**MEMORANDUM**

**SUBJECT:** Mandatory Referral No. 07403-MCPS-1: Wayside Elementary School Addition – 10011 Glen Road, Rockville, R-200 Zone, Potomac Subregion Master Plan

**STAFF RECOMMENDATION:** Staff recommends approval with the following comments:

# Attachment #5: Traffic Queuing Diagram

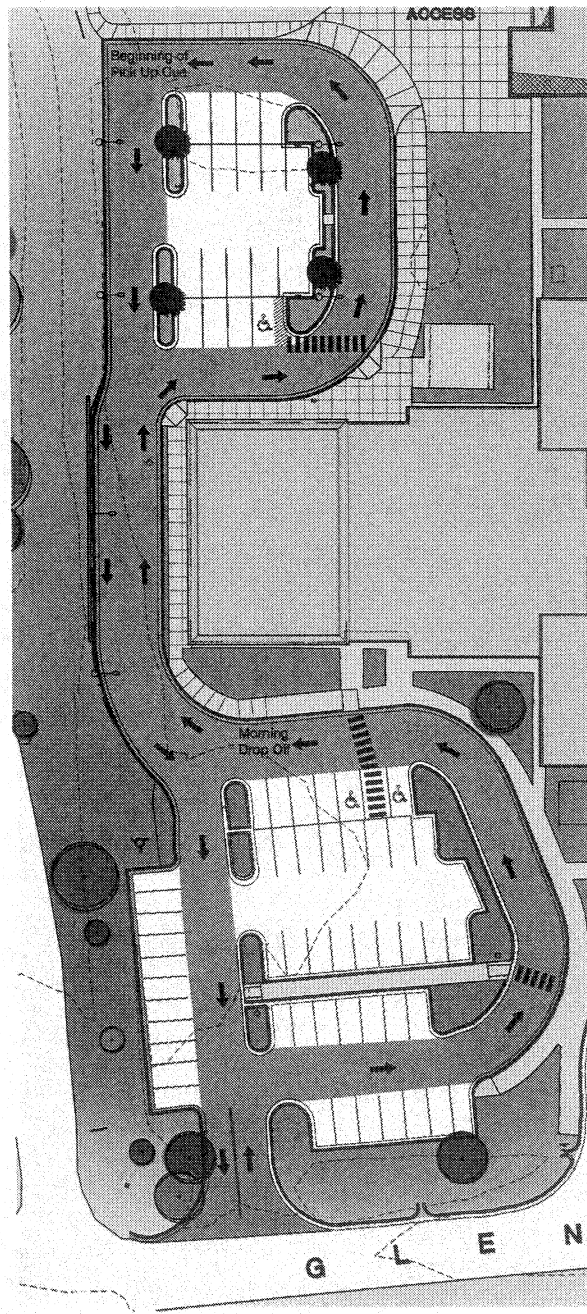
The applicant has submitted a queuing analysis to ensure that there will be no school-associated vehicles stack (queue) on off-site streets during the morning drop-off and afternoon pick-up periods. The queuing analysis submitted by the school demonstrates that there will be adequate stacking area to accommodate the total projected number of vehicles on-site during the afternoon pick-up period.

Staff finds that the proposed access to the school and internal vehicular/pedestrian circulation system as shown on the site plan is adequate.

# Attachment #6: Tree Save Plan

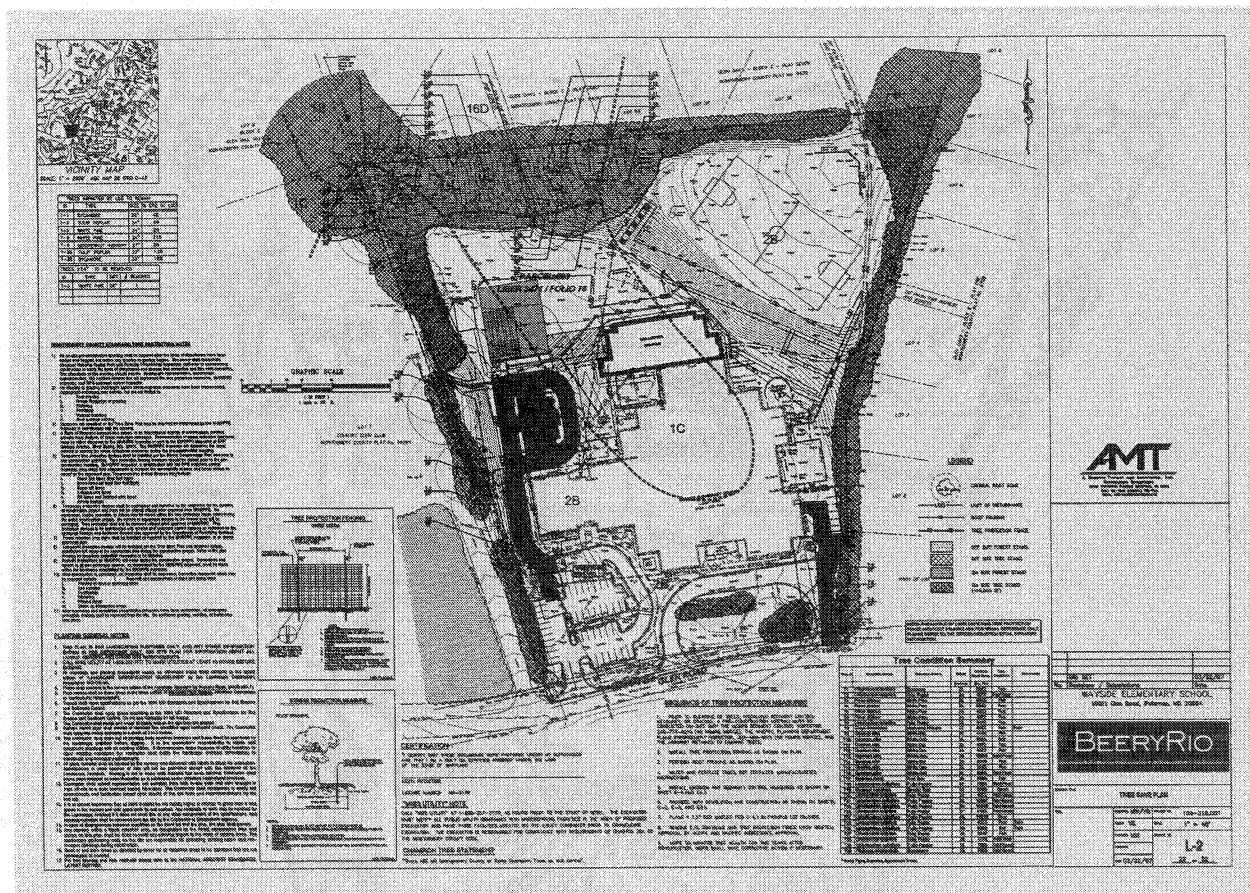
3. Final Tree Save Plan to be submitted for the M-NCPPC staff review and approval with final storm water management design; plan to conform to conditions of the final Tree Save Plan.
